Case 15ZONE1070 Simcoe Ln Rezoning, developer Cityscapes Residential

Regarding: **Drainage (Stormwater)**

Regarding: **Noise, line of sight, privacy of Hartwick Village homes.**

Regarding: **Rejection of Variance submitted for approval of 5 story (60') building**

Exhibit 2a Evergreen trees location and spacing

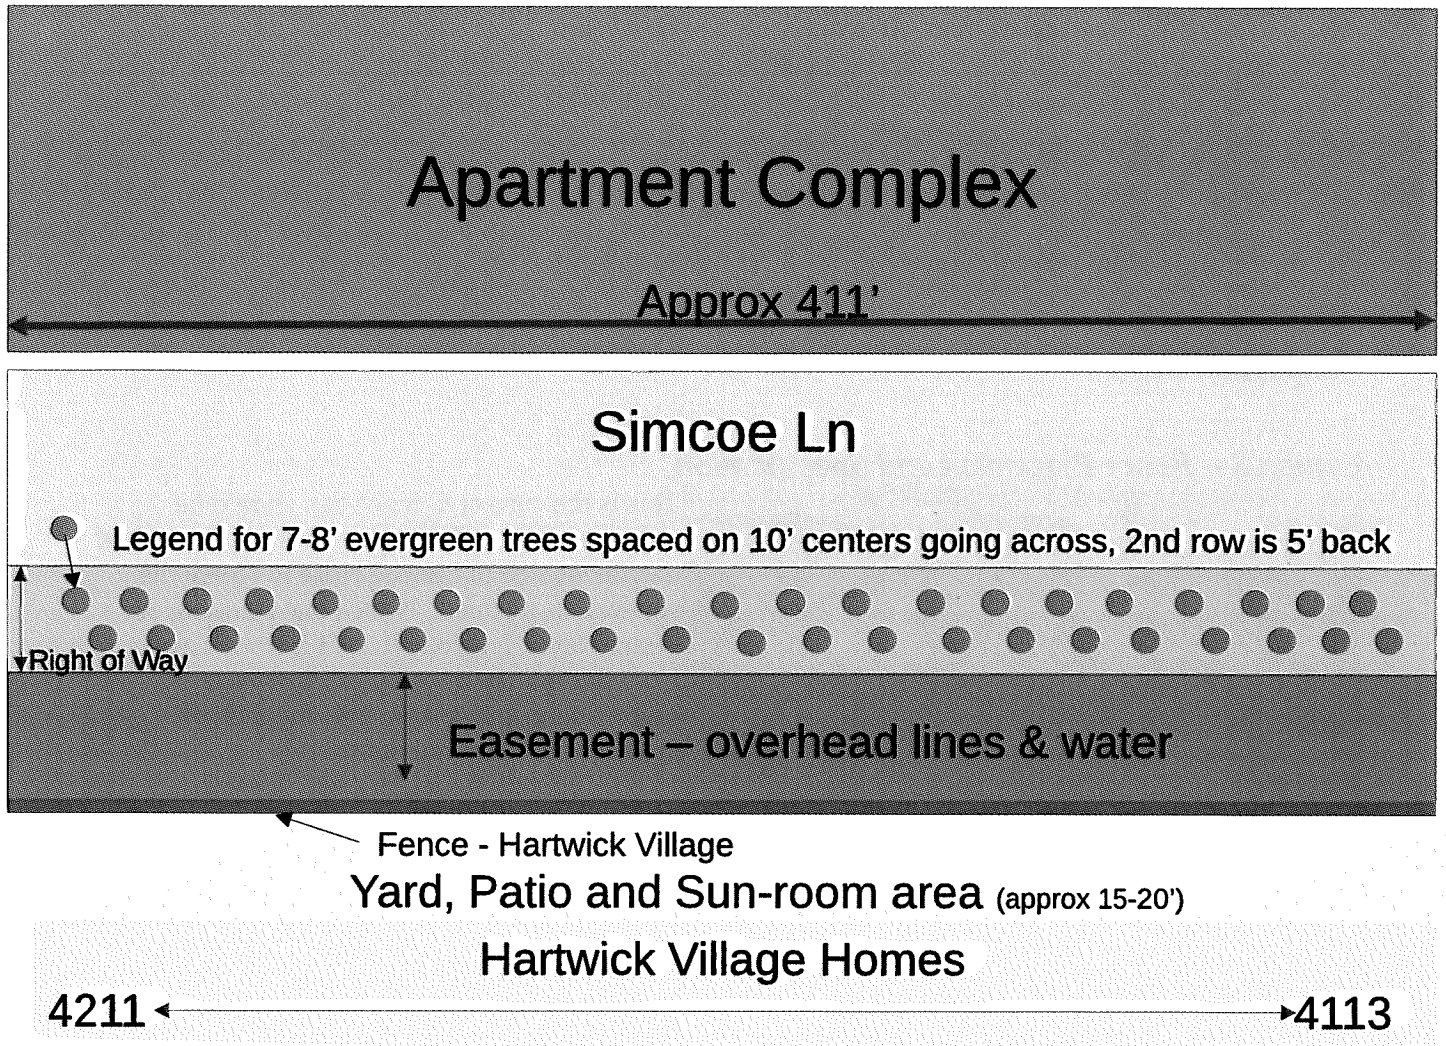
We met with Sherie Long and Erin Thompson from Planning and Design services on 2/19/16 and developed the following plan. The developer will plant a row of 7-8' evergreen trees or similar pines planted 10' off of Simcoe on 10' centers and a second row of 7-8' evergreen trees staggered behind the first on 10' centers (*see exhibit 2a*). These will be planted on the west side of Simcoe Ln (*exhibit 1*) the entire width of of the new development (approx 411') This will require the removal of 13 scrub trees (*see exhibit 2b*). The overhead lines have been considered and this plan will not interfere with them. As the trees mature and grow they will provide a sound barrier from the additional traffic as well as raising the line of sight higher from the balconies and windows of the apartment residents across the street. We confirmed with Peggy Heustis (horticulturist) of Greenscapes that this is a good plan and the trees are compatible with the growing conditions for this area.

Exhibit 1 Line of Sight

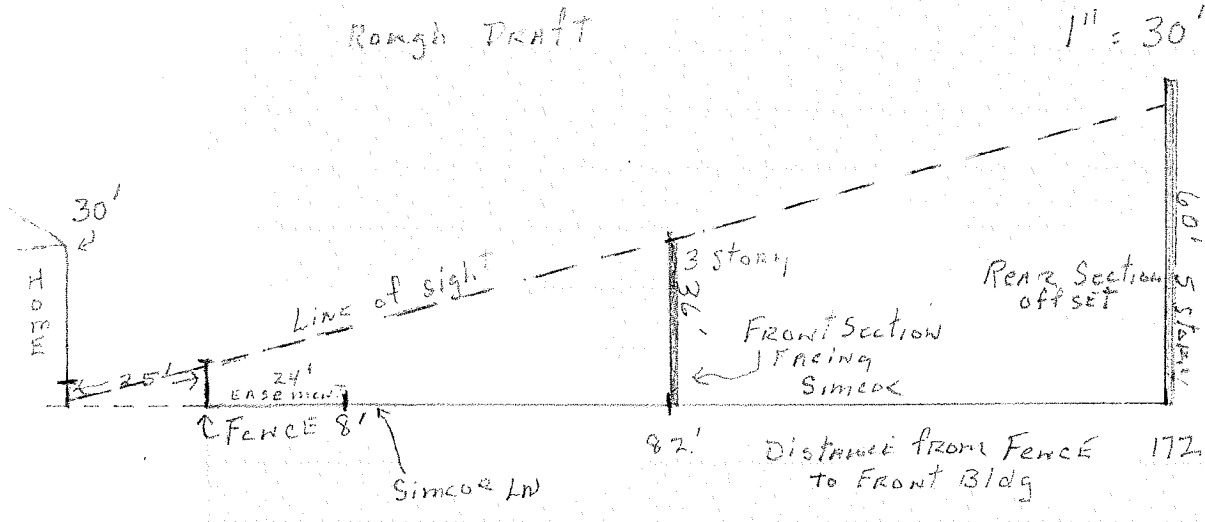
As this rough diagram illustrates those residents above the 2nd floor will have a direct line of sight view into the back yards, patios, sun-rooms and lower windows of the home in Hartwick.
